Canterbury District Local Plan 2040: Regulation 19 Representation

Representation By: Westbere Village Preservation Society

Policy / Site Reference: Policy R6 – Bread and Cheese Field (SLAA163)

Settlements: Westbere and Hersden

Fig. 2 (Arrow added)

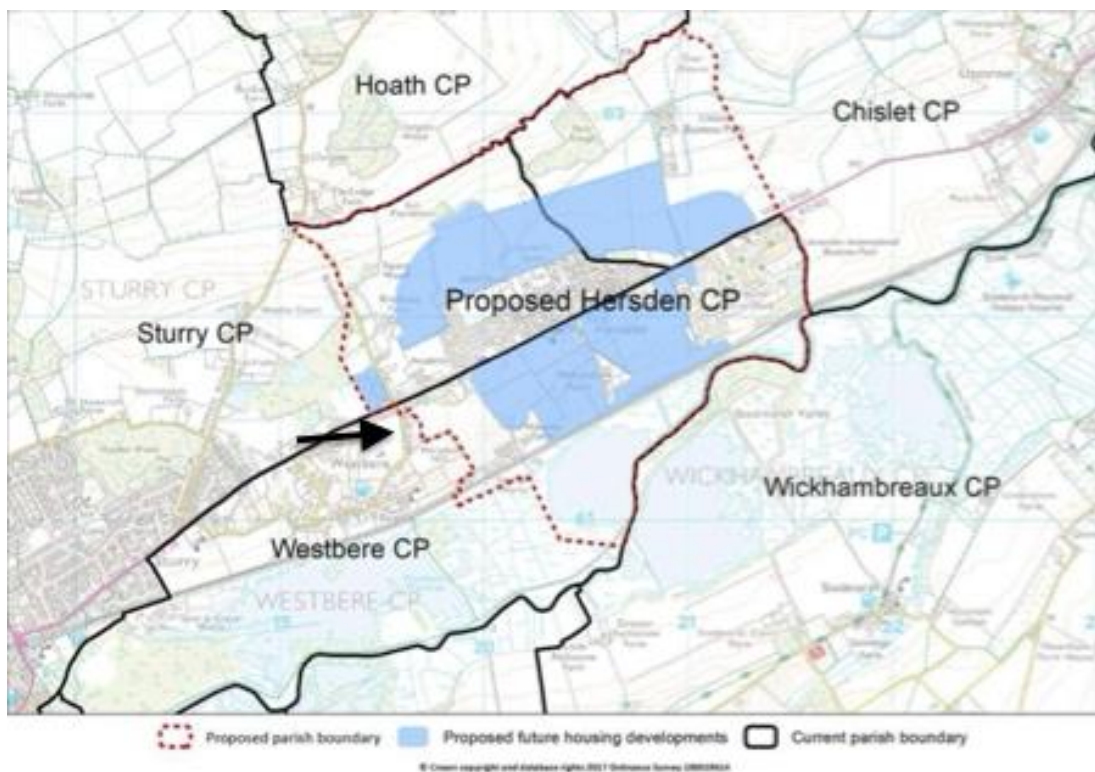
Following consultation, the final proposals approved by Full Council in **July 2018** included a revised boundary map. (Fig 2).

This revised map:

1. Differed materially from the map previously circulated during consultation
2. Altered the previously consulted boundary alignment without any further public consultation
3. Included the entire Bread and Cheese Field within the newly created Hersden Parish

WVPS submits that:

1. This constituted a change of material relevancy to the consultation proposal
2. By moving the Field from a Local Service Centre to a Rural Service Centre it materially affected the future planning context of the site

3. The decision to include all the Field within Hersden established a planning narrative that later under-pinned the Local Plan R6 Policy; it was however, a decision that was fundamentally flawed and which was eventually reversed by Canterbury Council but which would continue to guide the Policy.

Fig.5

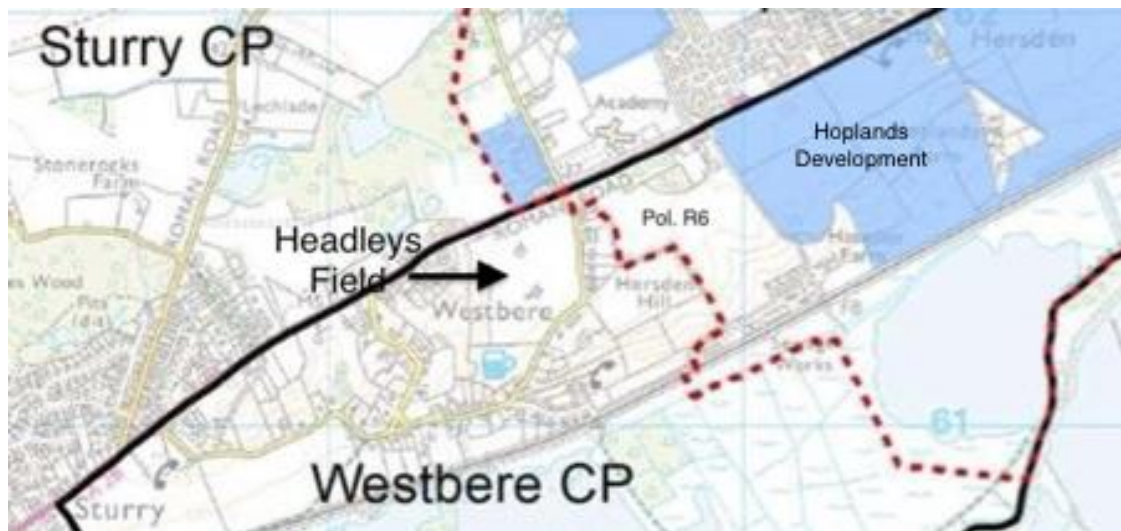
The Local Plan currently proposes an alternative Green Gap location, locally known as **Headley's Field**. (Fig 5)

WVPS submits that this location is fundamentally unsuitable for fulfilling the strategic purpose of a Green Gap. Headley's Field:

1. Lies well within the Westbere Parish
2. Does not form the primary separation between settlements
3. Does not prevent physical merging of built areas
4. Does not provide meaningful spatial separation between Westbere and Hersden

1. Its designation does not achieve the intended policy objective
2. It fails to address the actual risk of settlement coalescence
3. It represents an ineffective spatial solution

Retaining Headley's Field as the primary separation area is inconsistent with established Green Gap methodology.

Reclassify Headley's Field as Countryside

1. Does not serve Green Gap function
2. Lies within Westbere settlement context
3. Does not prevent coalescence
